## ADDENDUM

### S95 DETERMINATION DECISION OF WAITAKI DISTRICT COUNCIL ON A SUBDIVISION AND LAND USE RESOURCE CONSENT APPLICATION

| <b>Consent Number:</b>      | 201.2020.1603  |
| <b>Site Address:</b>        | 23 and 25 Te Karita Rd, Moeraki  |

23 & 25 Te Karita Road, Moeraki  
Landscape Development Concept

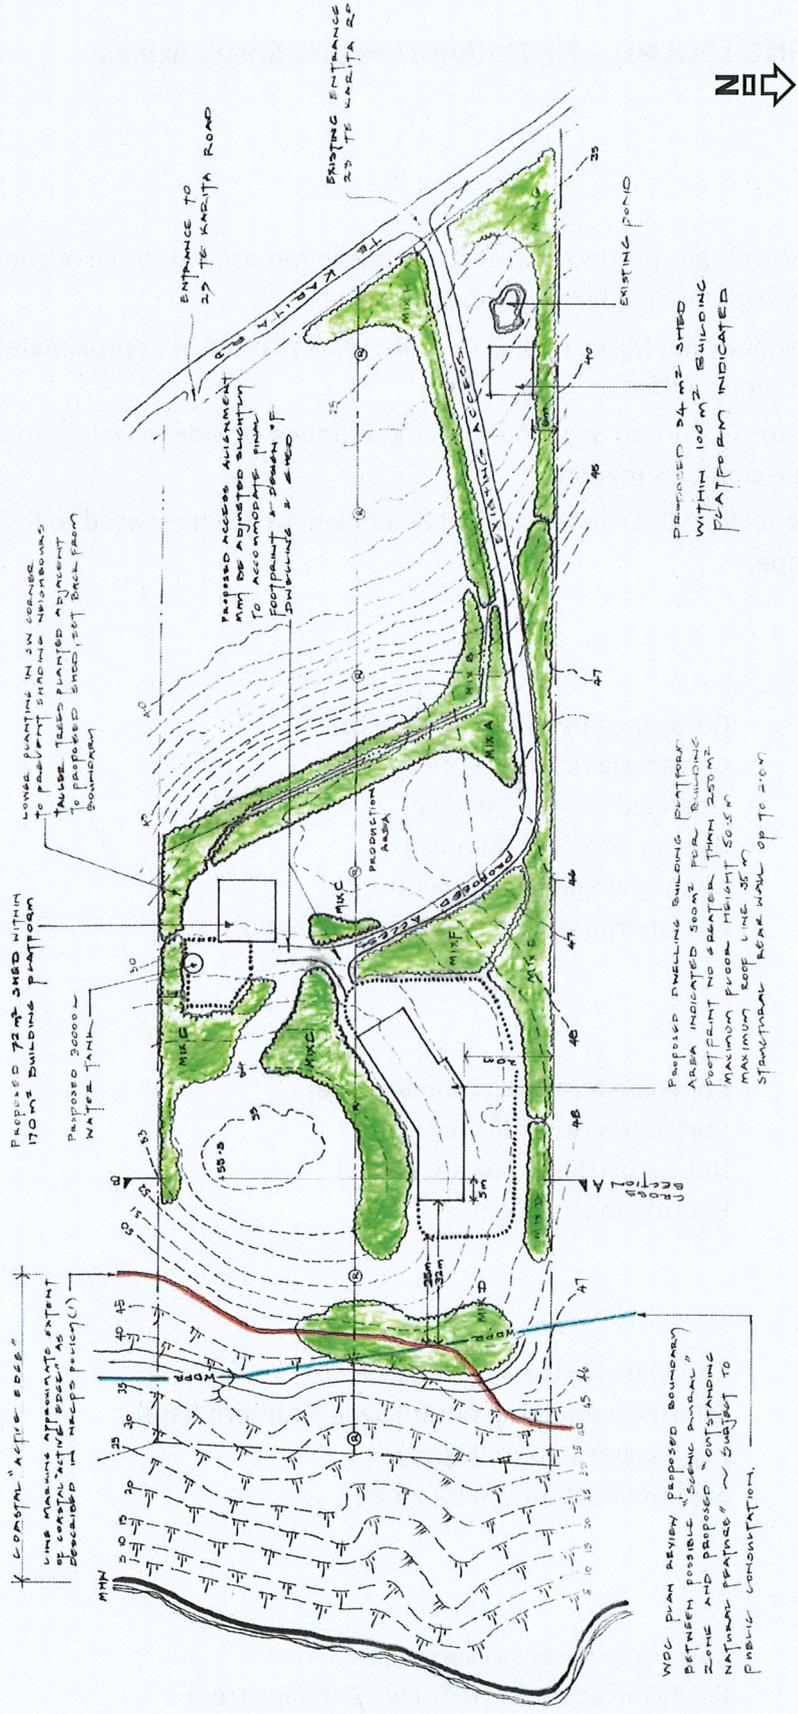
Some of the planting that would have formed a backdrop to the dwelling mitigating this effect has been removed (planting on the northeast "corner" of the central knoll). New planting is proposed further east on a lower elevation (48-50m above datum mostly). The shrub species proposed in Mix D will not grow high enough provide a backdrop and the tree species in the mix will provide a low backdrop approaching roof height but are unlikely to appear higher than the roofline sufficiently to meaningfully absorb it by providing a backdrop. This effect is slightly increased with the .5m increase in elevation of the proposed dwelling and increase in height, effectively raising the roofline to 55m as compared to 54.5m as previously proposed.

However, planting to the west of the building will most likely grow to screen out views of the future dwelling (and curtilage) thus mitigating this effect.

The absence of any mitigation related to the driveway and new shed closest to Te Karita Road was also noted. The proposed planting on the new plan would address this issue. The new planting is unnaturally linear in appearance and will highlight the boundaries. However, this adverse effect is considered to be less than minor and would over time be likely to be softened by additional planting. It is acknowledged that linear planting of native species for shelter, or any other purpose, is a permitted activity. The positive effects of extensive native planting for habitat and connected to other extensive plantings across the site, are also to be considered.

The removal of the proposed earth mounding to the west of the BP is in itself neutral in effect. It does mean however that the planting in Mix F will take longer to achieve screening effect of the dwelling (refer comment above, however).

The slight shift of the 72m<sup>2</sup> shed on the knoll, a looser exact location within a proposed BP of 170m<sup>2</sup> and the addition of a curtilage area behind the shed would have no additional degree of adverse effect. My comment on the screening ability of the proposed planting applies here also.

The removal of the shed to the west of the BP reduces the adverse effect of several buildings on landscape character slightly and allows for bulking up of the proposed planting in this area, thus is a positive change.

ASLA had recommended a limitation of future land uses on the land east of the central knoll to pastoral and/or ecological restoration uses. This is now proposed as a consent notice condition (east of a north-south line 5m east of the highest point of the knoll) and is supported. This line needs to be marked on the plan.

The proposed condition to allow LVR for roofing and cladding materials to 40% is not supported. Once the native planting grows around the buildings they will provide a darker context than the existing open pastureland. An upper LRV limit of 20% for roofing and 25% for cladding is recommended to ensure wall and roof planes are absorbed into the surrounding native plant foliage. The 10% lower limit is supported.
